## SERVICE BULLETIN

**BULLETIN NO:** 20-008A

**TITLE:** CALLISTO MOUNTING WING UPDATE

FIGURE-1  
CALLISTO WING MODIFICATION - MOVE BOX LEFT

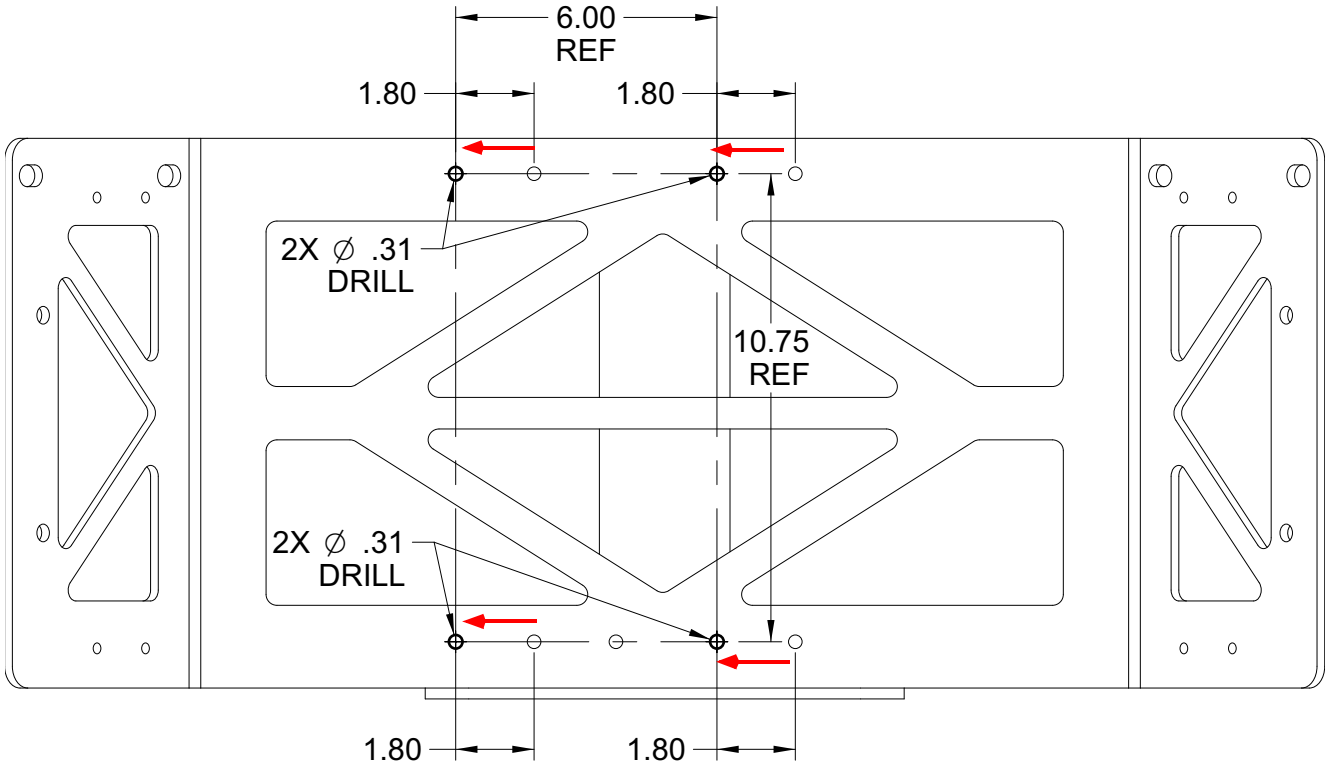
If the Arrow on the IMU Decal IS NOT aligned with the Machine Centerline, the Callisto 2 Box Assembly must be offset 1.80 inches in the proper direction, left or right - in order to align the IMU Decal Arrow with the machine centerline. This will require new mounting holes to be drilled in the Callisto Wing bracket to properly mount the Callisto 2 Box Assembly.

1. Remove Callisto wing and box.
2. Remove box from wing, noting the orientation of the box on the wing.
3. Following the drill pattern shown in Figure 1 or Figure 2, make four new 5/16" (.31 inch) diameter holes. Offset the new holes 1.80 inches from the existing holes.
4. Mount box back onto wing using the newly drilled holes - in the same orientation it was in prior to removal.

**FIGURE-3**  
**CORRECT PLACEMENT OF THE BOX SHOWING THE IMU DECAL**

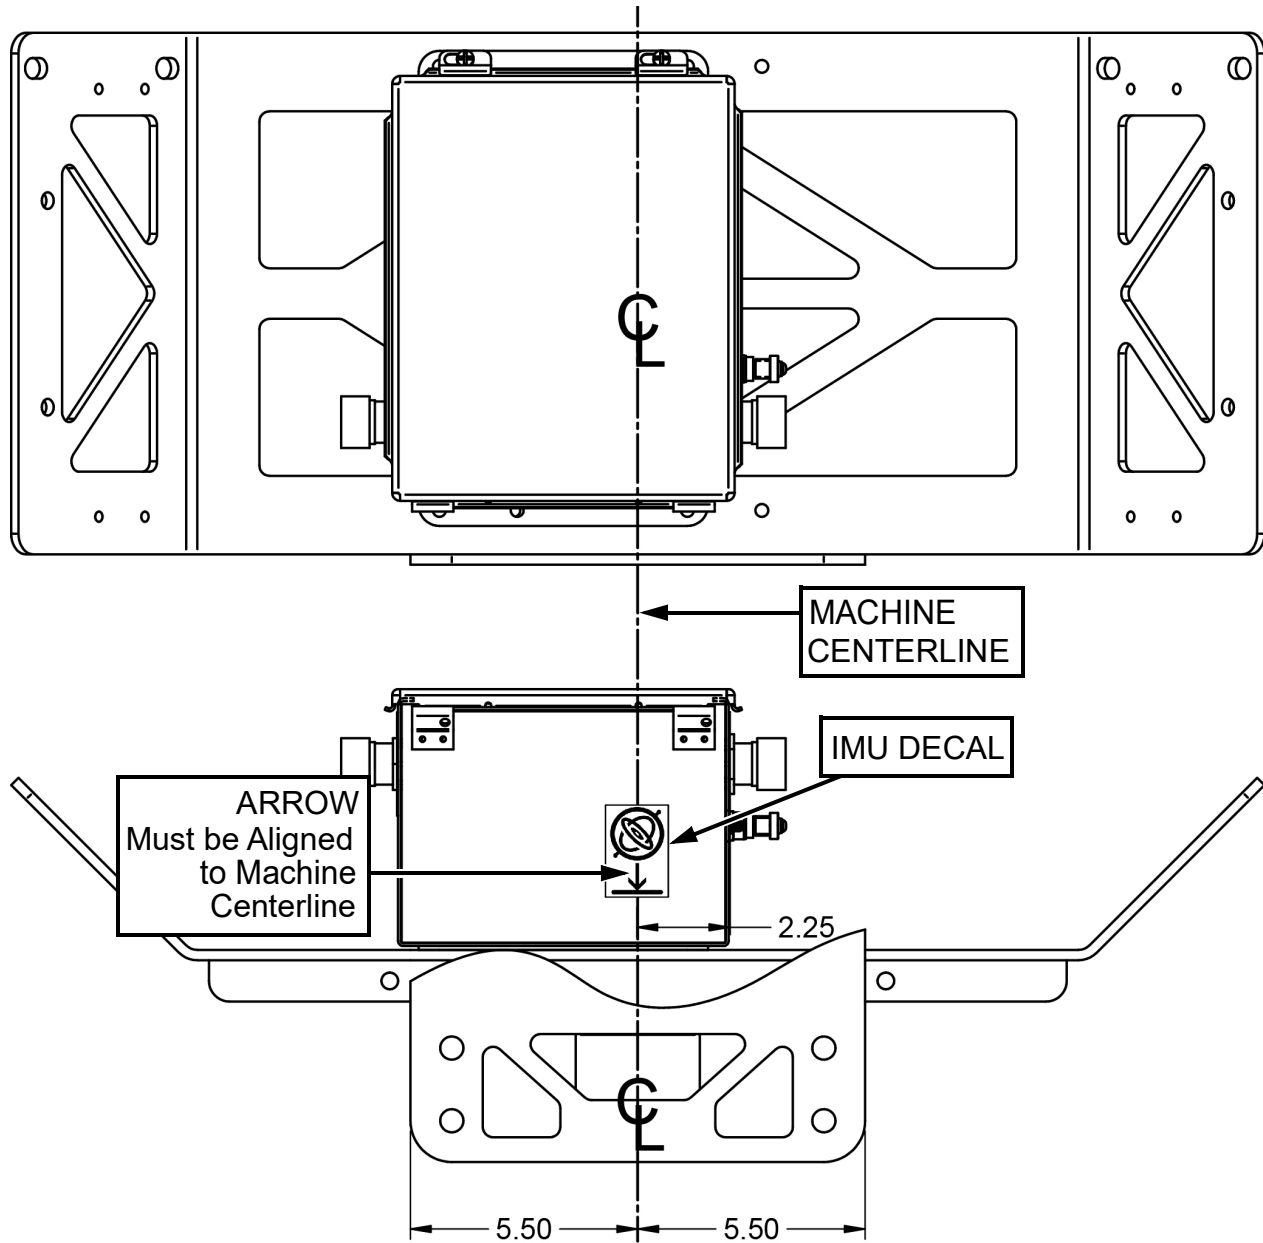
On the side of the Callisto 2 Box Assembly there is an IMU Decal. The IMU decal must face either the front or the rear of the machine. The decal has an alignment Arrow on it. If the Arrow on the IMU Decal IS aligned with the Machine Centerline, the Callisto 2 Box is mounted properly, and the Callisto Wing does not require updating.

5. Mount box and wing back onto tamper.
6. Verify that the IMU Decal Arrow is accurately aligned with the centerline of the machine.  
- (See Figure 3)
7. Verify box operation by recording track.
8. Sync back into the recording and check superelevation using a level board.

1. When remounting box, ensure that the Arrow on the IMU decal is accurately centered along the centerline of the machine.
